REMEDIAL ACTION
CONSTRUCTION COMPLETION
REPORT

VOLUME II
AS-BUILT DRAWINGS
& DESIGN CHANGE FORMS

Pine Street Canal Superfund Site
Burlington, Vermont

DESIGN CHANGE FORMS

DESIGN CHANGE #6: AREA 3/2 WATERWAY
 CROSS SECTION AT STATION 2+0
 PINE STREET ANAL SITE, BURLINGTON, VT

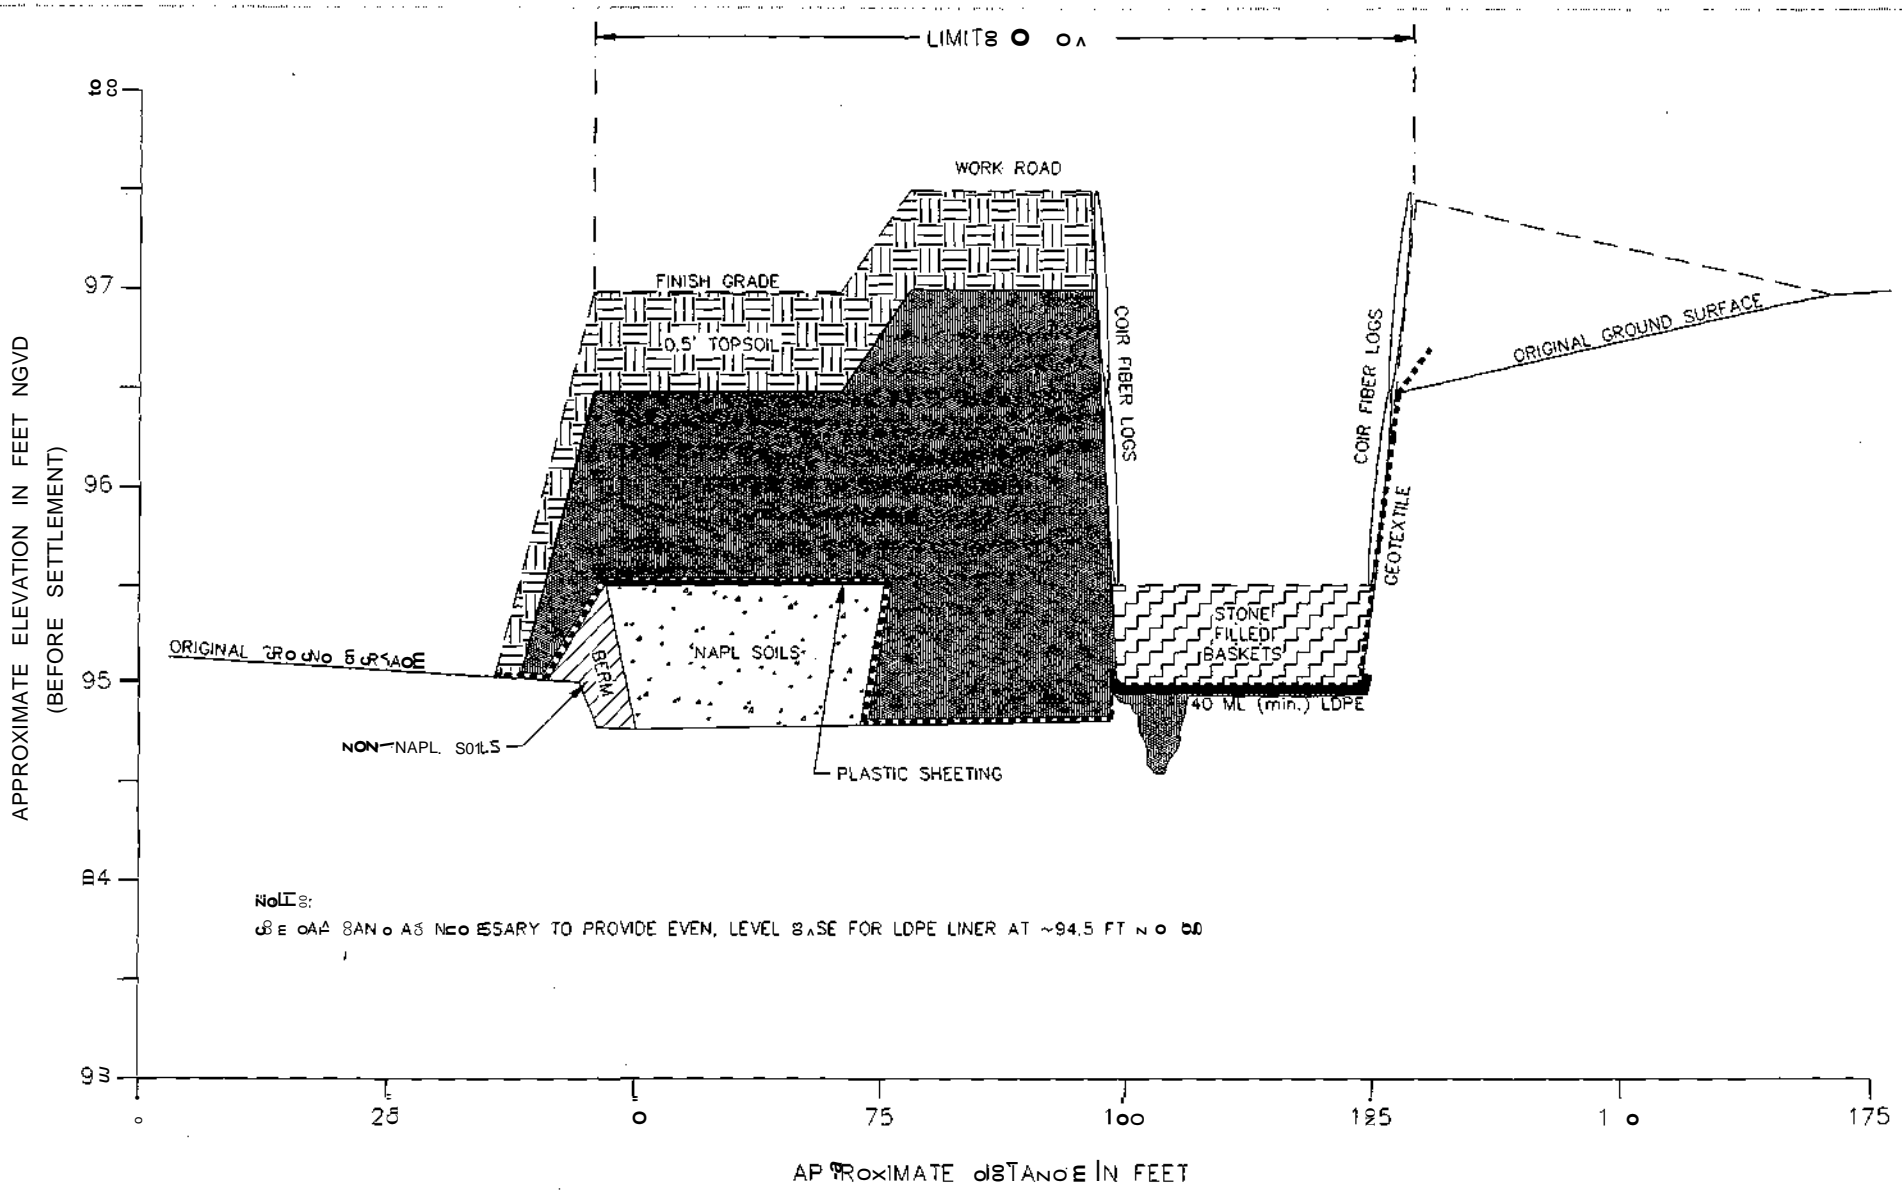
It is proposed that the six-inch thick sand bed below the stone-filled mattresses be eliminated between approximately Stations 0+00 and 2+50, and replaced with a 40 mil (minimum thickness) low density polyethylene liner. The newly proposed subgrade elevation will be at 94.5 ft NGVD. Any existing low areas (below 94.5 ft NGVD) will be filled with cap sand. The liner will be placed on the subgrade, covered with geotextile, and the mattresses placed on top. Please refer to the attached *Design Change #6A, Area V2 Waterway Profile* and *Design Change #6A, Area V2 Waterway Cross Section at Station 2+10* for details.

This change will reduce the volume of NAPL contaminated soils which must be excavated. The proposed change will not change the design final grade (before consolidation) of the waterway, and so will not affect its hydraulic capacity. The safety factor against erosion of the waterway will also be unchanged.

NOTES:
 BE CAREFUL AS NECESSARY TO PROVIDE EVEN, LEVEL BASE FOR LDPE LINER AT ~94.5 FT NGVD

DESIGN CHANGE #6A
 AREA 3/2 WATERWAY PROFILES
 PINE STREET CANAL SITE, BURLINGTON, VT

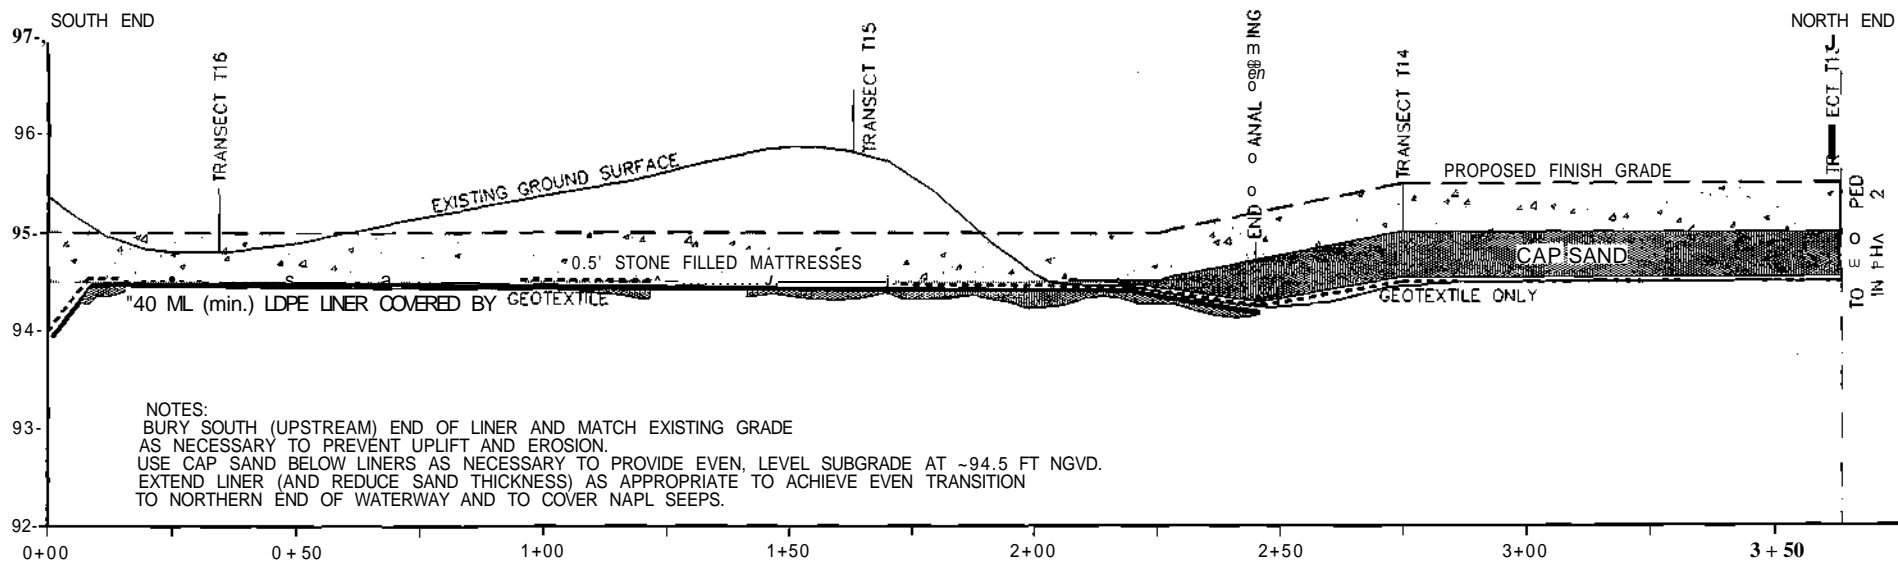
As shown on the attached Grading Plan and Profile, Station 2+50 marks the approximate southern extent of where the Canal was formerly dredged. The proposed design change includes the use of the plastic liner between Station 0+00 to approximately 2+50 (plus or minus 25 feet). However, the proposed change also allows extensions of the area where the plastic liner replaces the sand bedding as necessary based upon field conditions to promote a smooth transition to the remaining portion of the waterway and to cover locations with visually observed NAPL seeps.

NOTES:
 BURY SOUTH (UPSTREAM) END OF LINER AND MATCH EXISTING GRADE
 AS NECESSARY TO PREVENT UPLIFT AND EROSION.
 USE CAP SAND BELOW LINERS AS NECESSARY TO PROVIDE EVEN, LEVEL SUBGRADE AT ~94.5 FT NGVD.
 EXTEND LINER (AND REDUCE SAND THICKNESS) AS APPROPRIATE TO ACHIEVE EVEN TRANSITION
 TO NORTHERN END OF WATERWAY AND TO COVER NAPL SEEPS.

FIGURE 1
 AREA 2 WATER WAY
 SITE PLAN - NORTH END

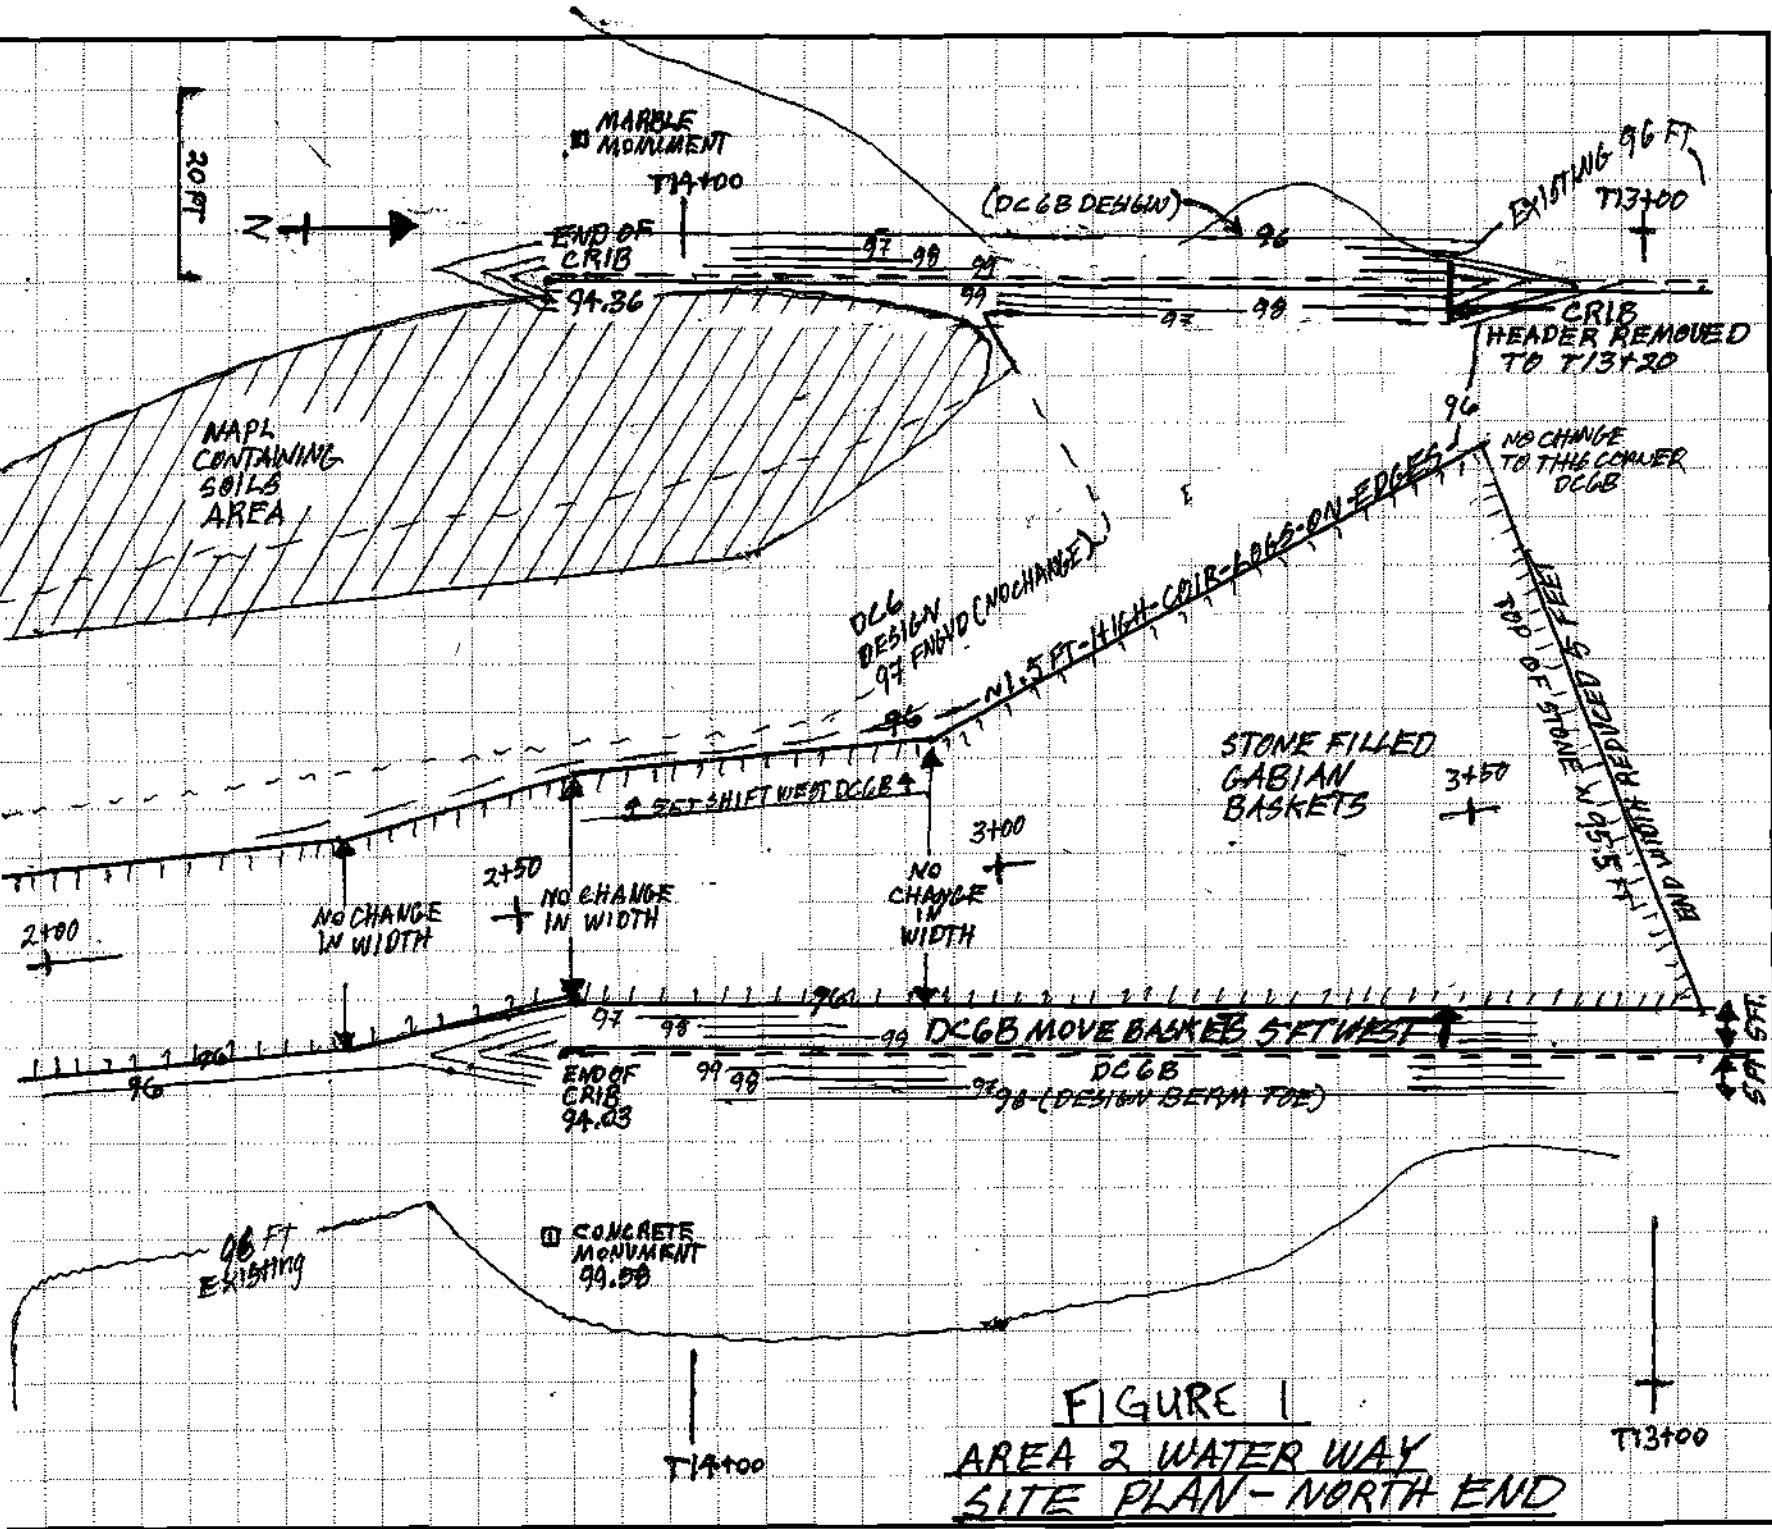
To address the concern of the rock baskets near the cribbing pathway, this design change proposes to re-locate the Area 2 waterway five feet westwards from its current design location (without changing its overall width). The change will affect the Area 2 waterway from approximately centerline Stations 2+25 to 3+60 (see attached plan on Figure 1). In addition, this design change proposes placement of an additional 60 mil LDPE liner over to the east cribbing.

FIGURE 2
LINER PLACEMENT
 AREA 2 WATER WAY
 SITE PLAN - NORTH END

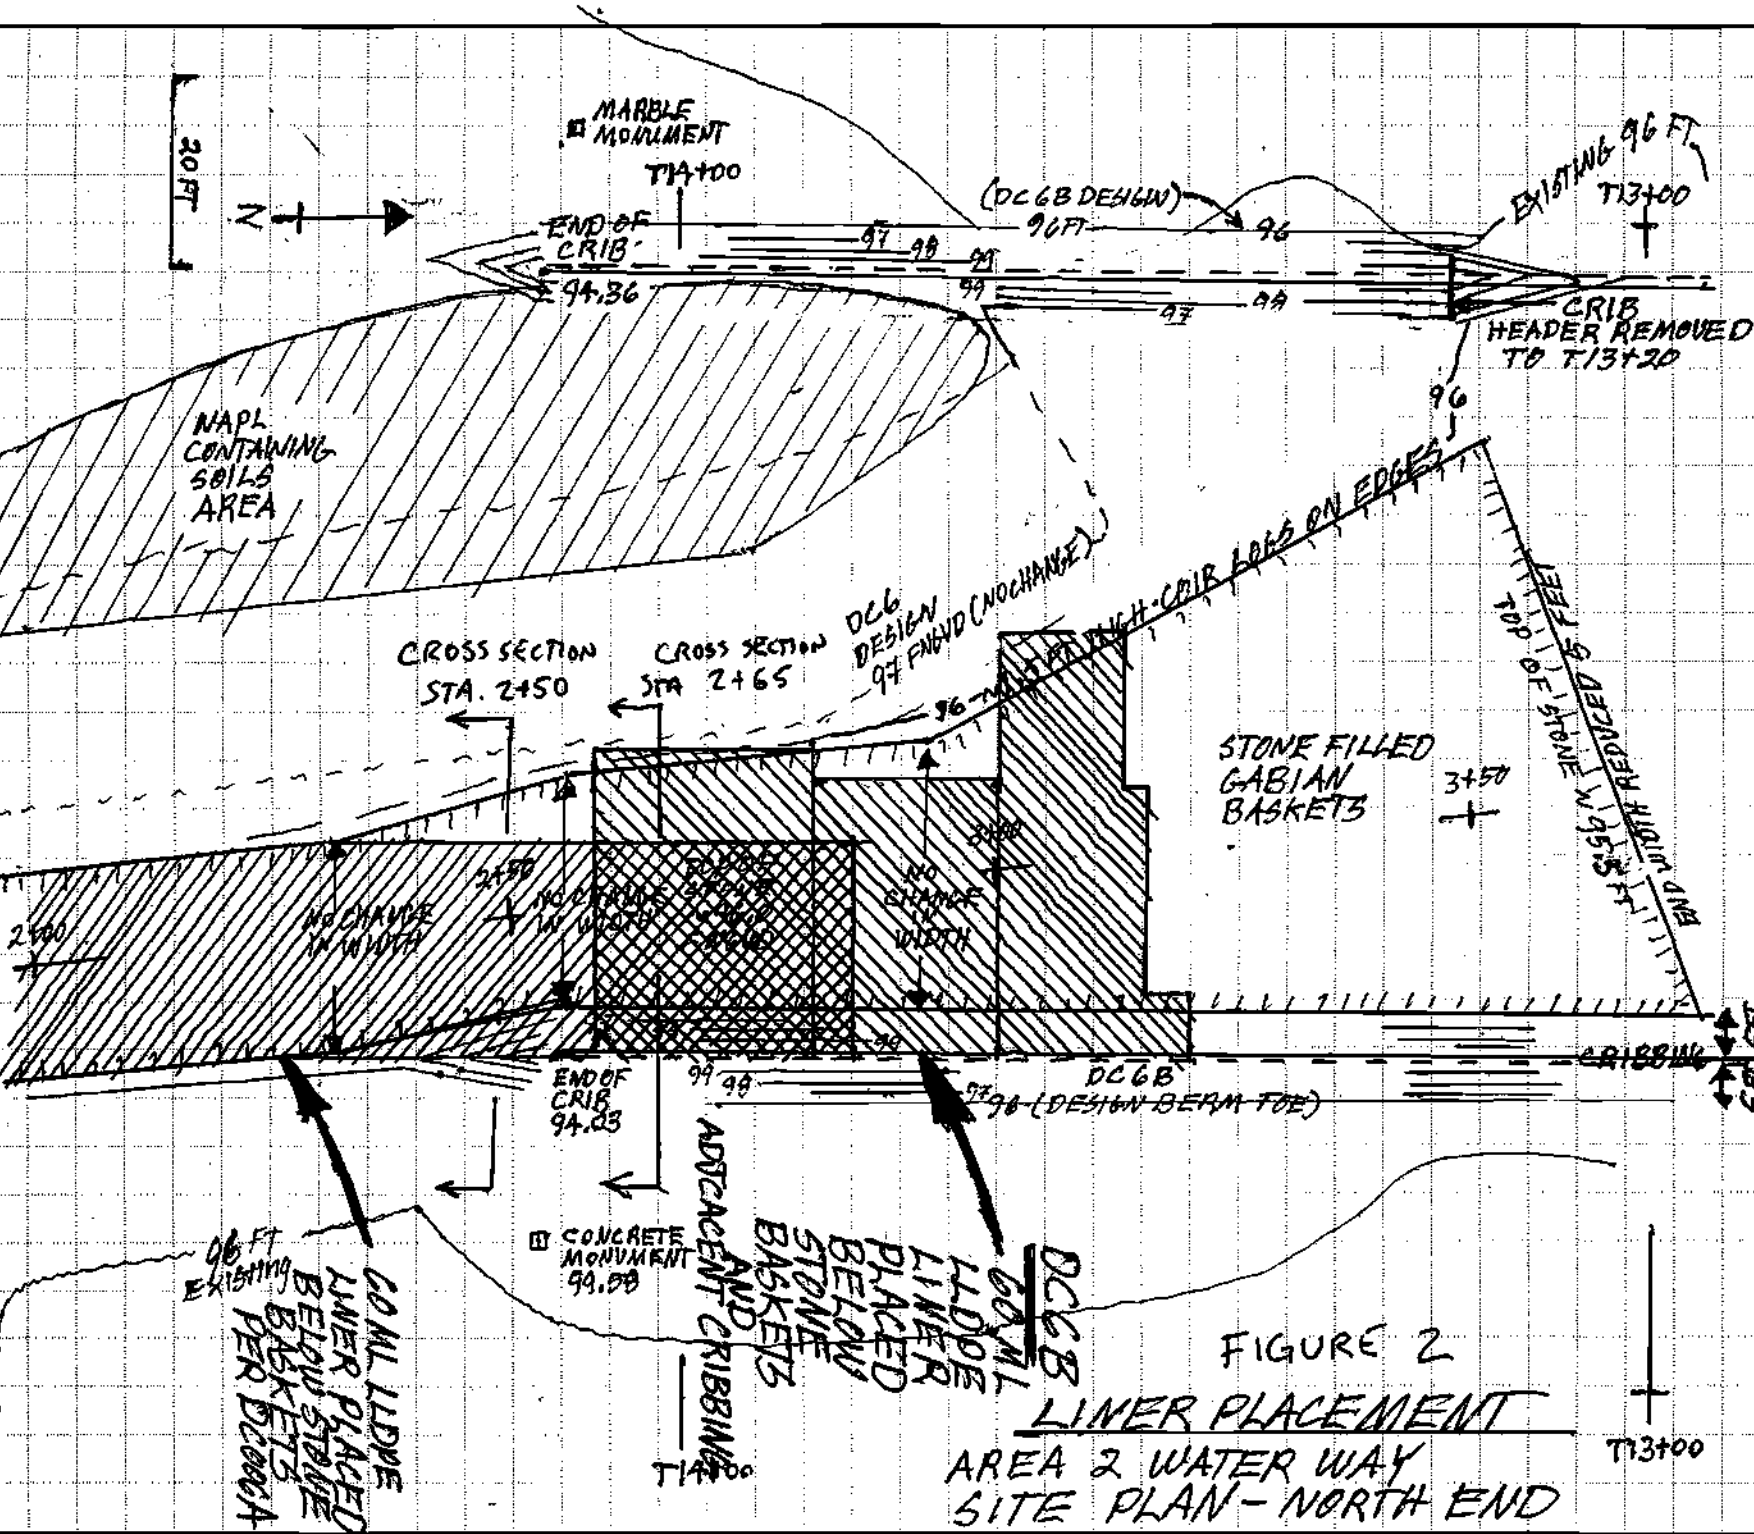
To address the concern of removing the buried cribbing header, a revised treatment of the top of the east and west cribbing where the header beam is at or beneath the sediment surface is proposed. This revised treatment involves placement of sufficient cap sand (approximately five feet) over the cribbing to prevent any upward migration of sediment via the cribbing walls, without removing the header beam (see attached cross-sections on Figure 3 and 4). This sand berm would extend five feet past both sides of the cribbing (and in places on the east cribbing, extends onto the LDPE liner - see attached plan) in order to provide sufficient cap thickness in all directions from the cribbing (at least 1.5 feet).
